## HISTORIC AND DESIGN REVIEW COMMISSION

Agenda Item No: 23

**HDRC CASE NO:** 2016-283  
**ADDRESS:** 110 GLORIETTA  
**LEGAL DESCRIPTION:** NCB 576 BLK B E 9.45 FT OF 2 & W 29.55 FT OF 3 ARB A13  
**ZONING:** RM4 H  
**CITY COUNCIL DIST.:** 2  
**DISTRICT:** Dignowity Hill Historic District  
**APPLICANT:** Kyle Zochert  
**OWNER:** Kyle Zochert  
**TYPE OF WORK:** Historic Tax Certification, rehabilitation and a rear addition  
**REQUEST:**

### Windows

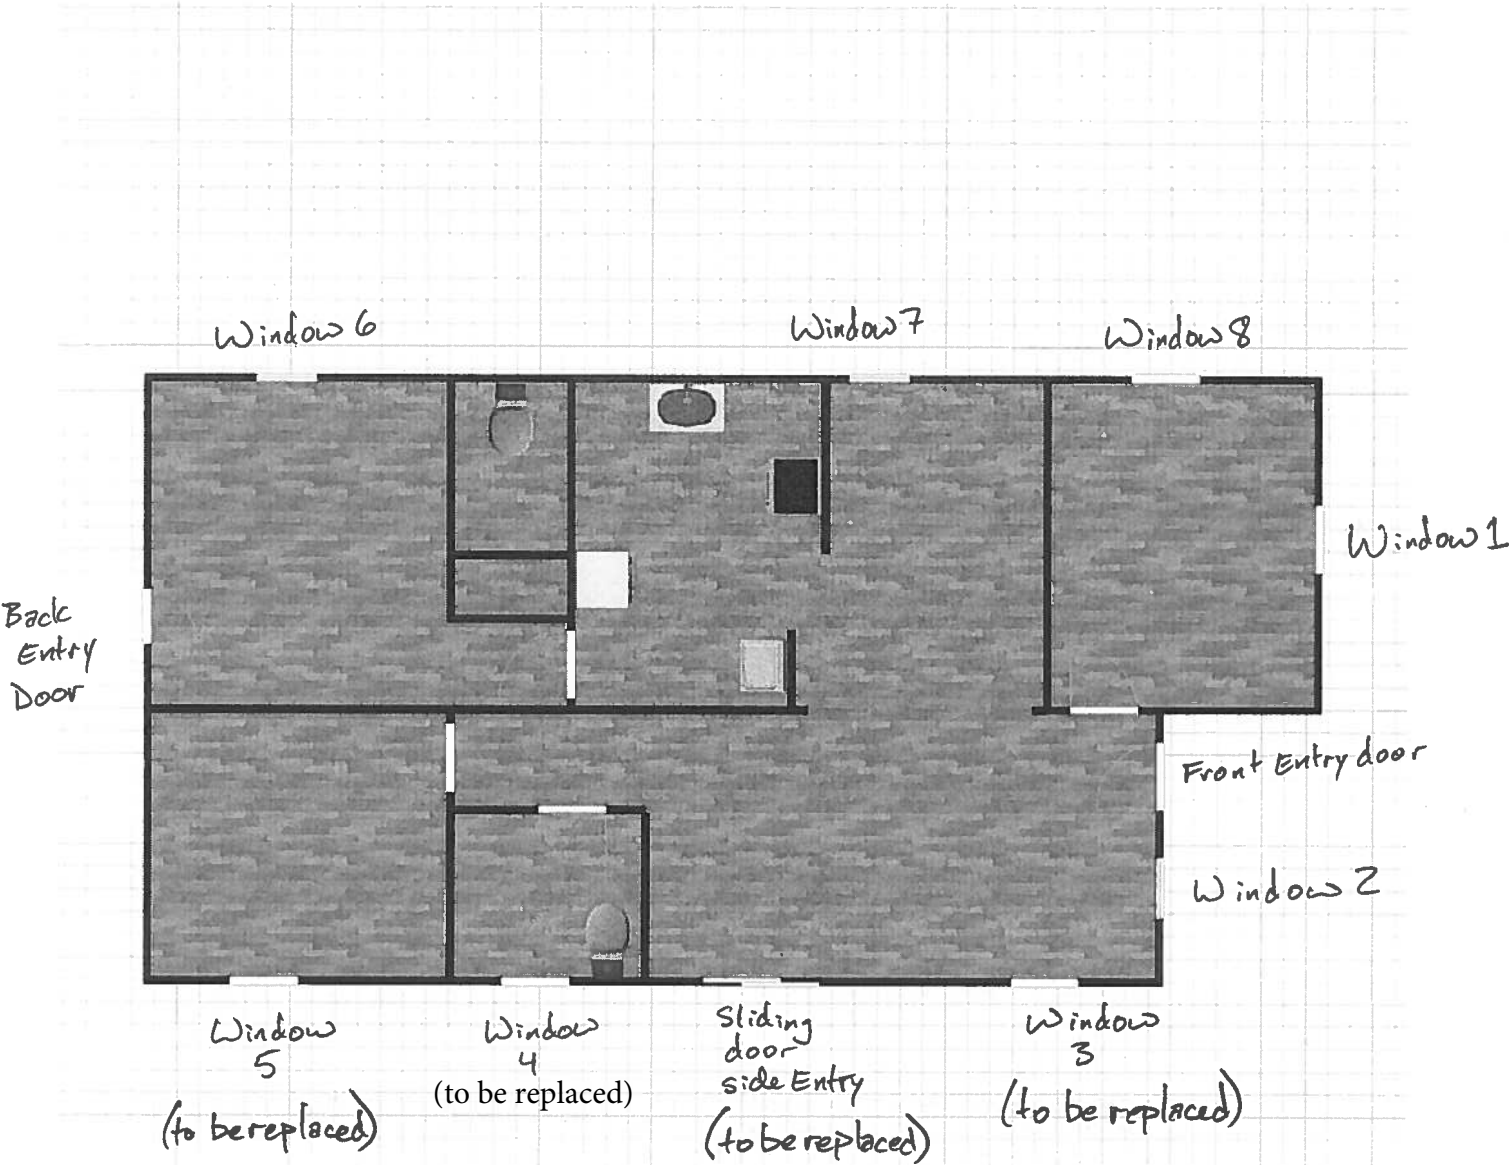
- e. The applicant is proposing to remove 3 existing metal windows on the left façade and replace with white single-hung vinyl windows. According to the Guidelines for Exterior Maintenance and Alterations 6.B., non-historic windows and doors should be replaced with elements that are typical of the architectural style of the building. Staff finds the proposed vinyl windows not consistent with the Guidelines and recommends the applicant install wood double-hung windows.

1. That the windows be made of wood, be double hung, feature clear glass and be inset two inches within the frame.
2. That the side and rear French doors be made of wood.
